The Banks – Phase 3C
Public Infrastructure Development
Bid Package #2 – Lot 28 Park & Garage
January 13, 2022
THP #98090.40

ADDENDUM #2

8 BLEACHER SEATING PLAN
A510.2 1/2" = 1'-0"

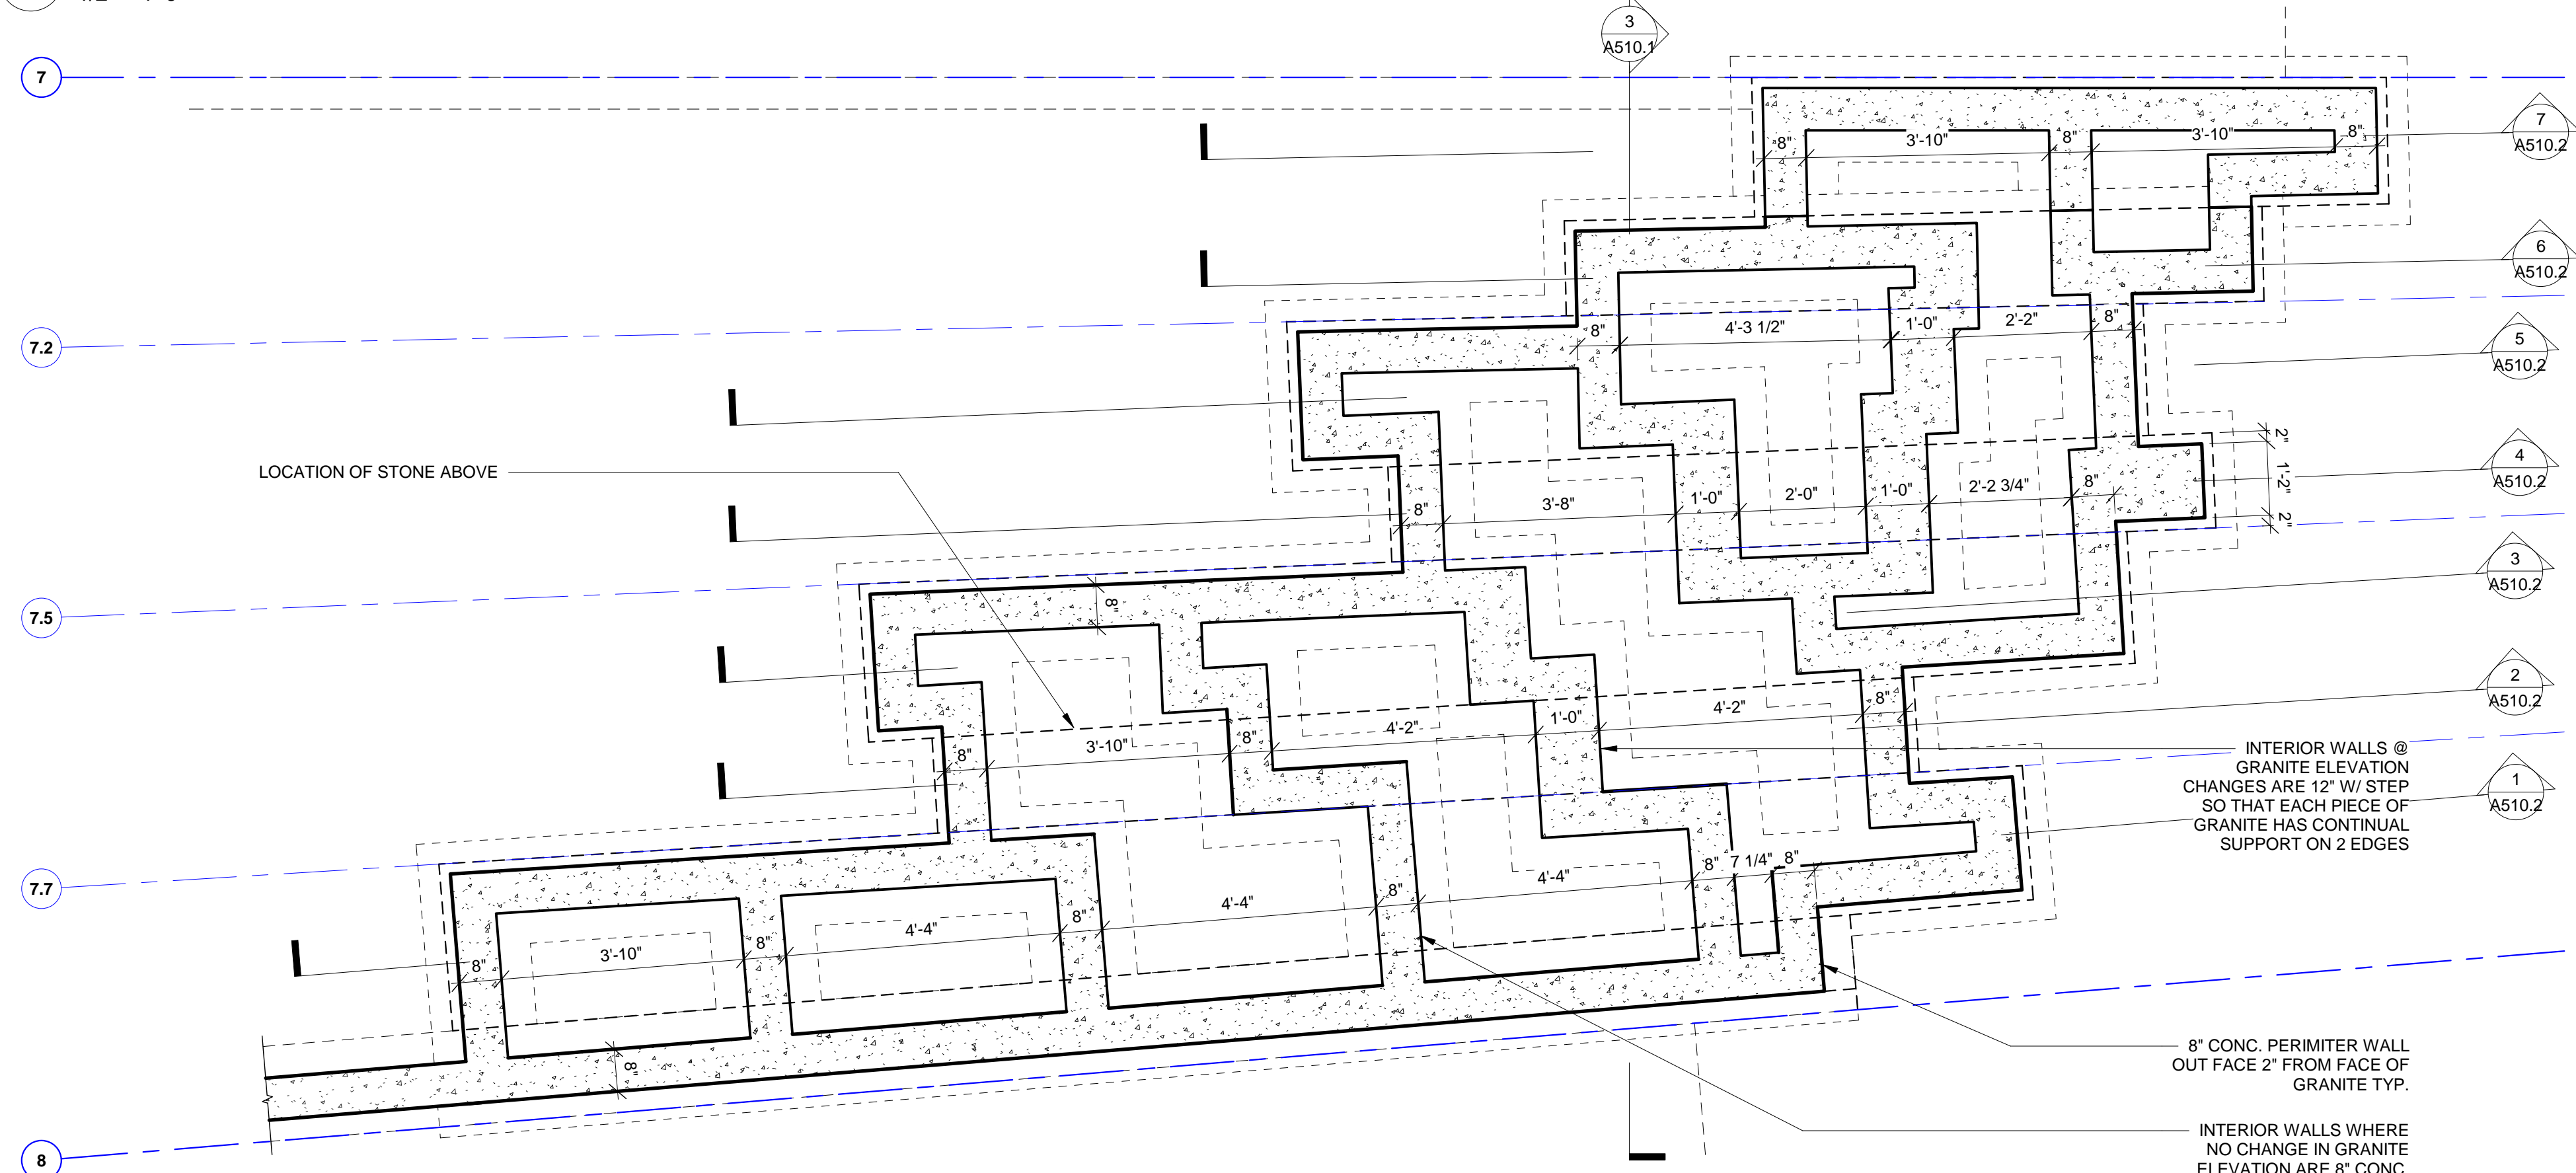
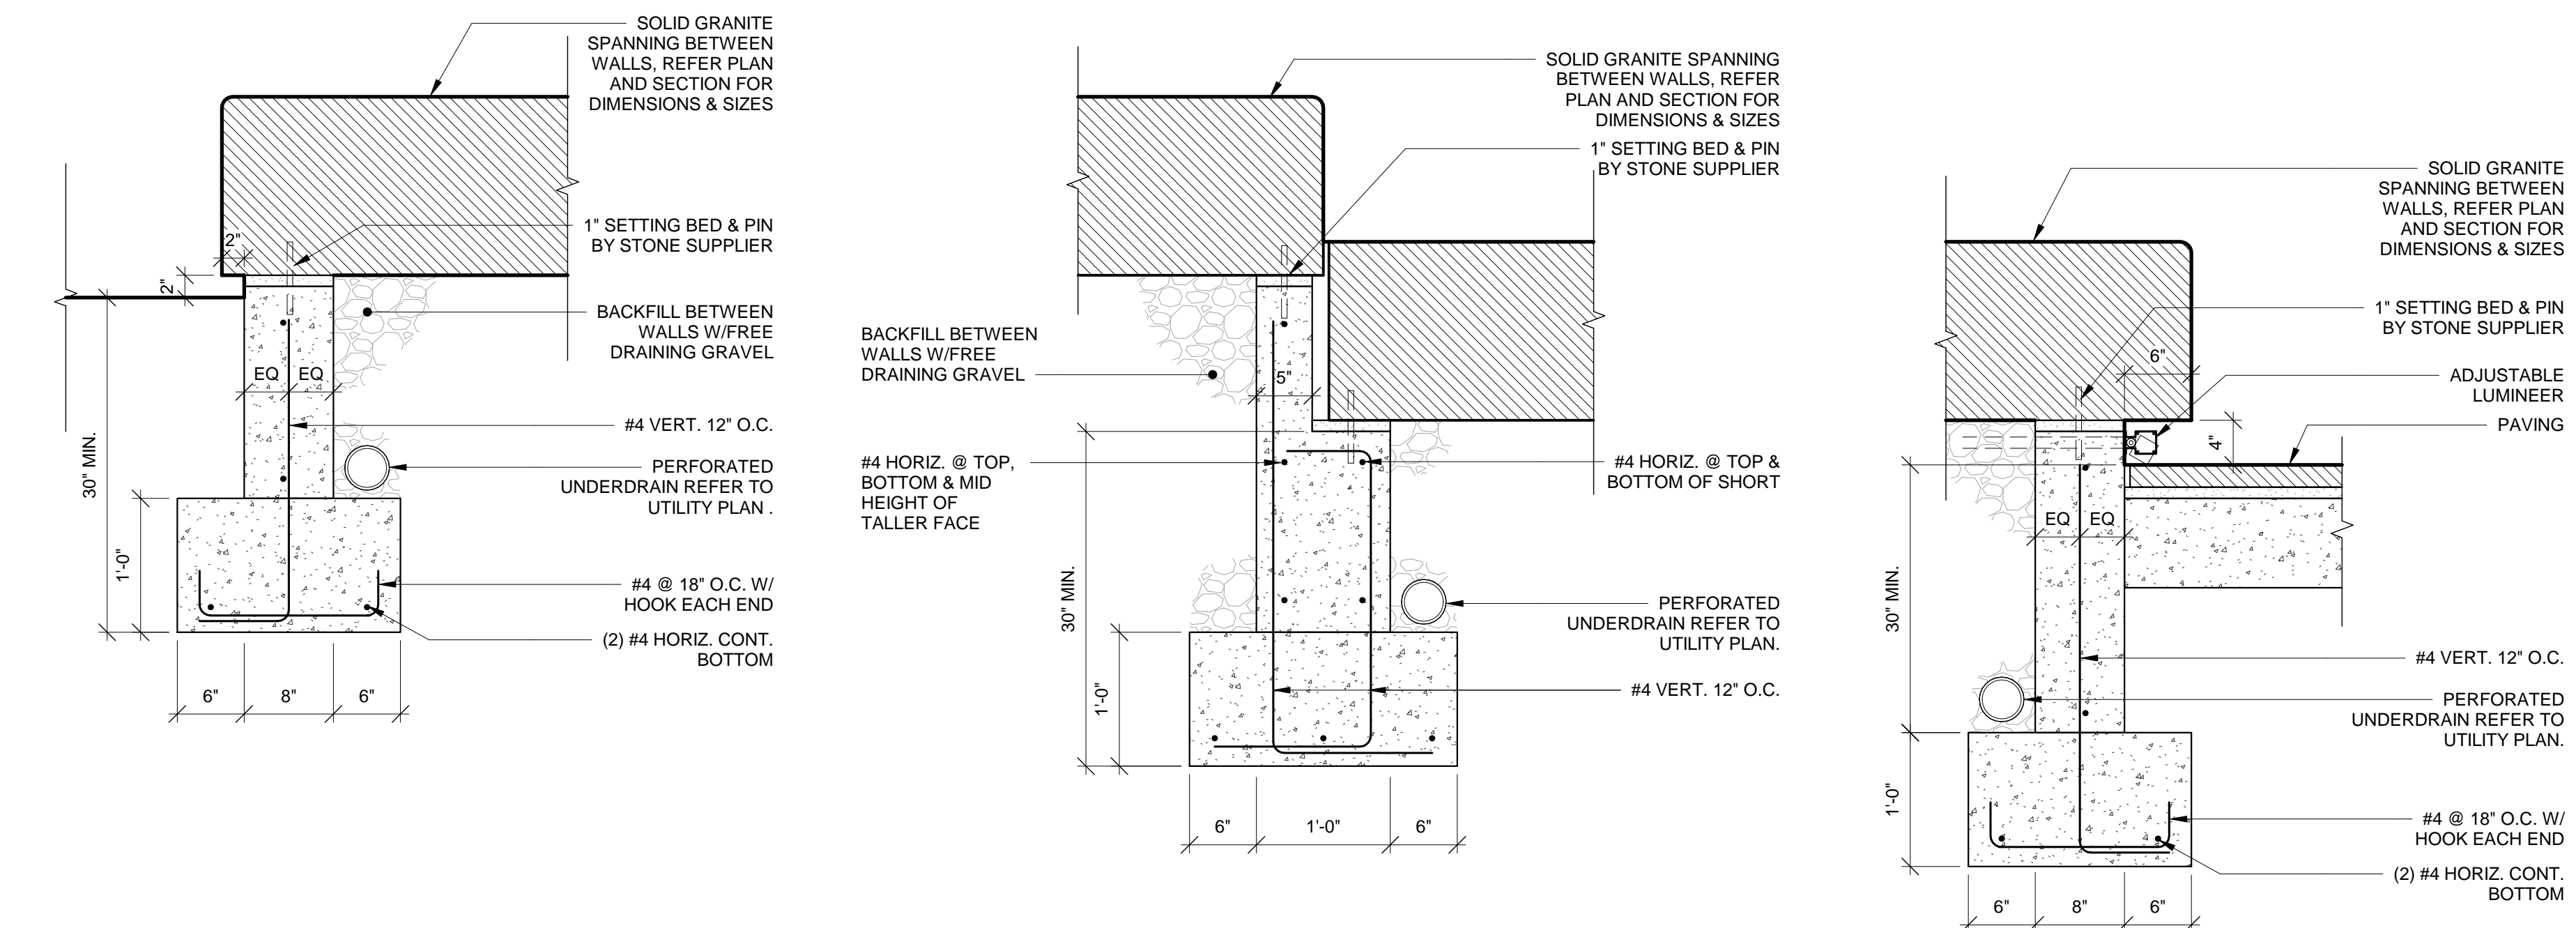
6. **A510.2** Please provide reinforcing details, elevations, and dimensions for all concrete back up foundations, for granite elements.
 - **Response to question 6:** See revised Drawing A510.2 in Addendum #2.

- Updated foundation layout
- Updated sections to respond to new foundation layout
- Added details w/ structural notes (Baker question 6)
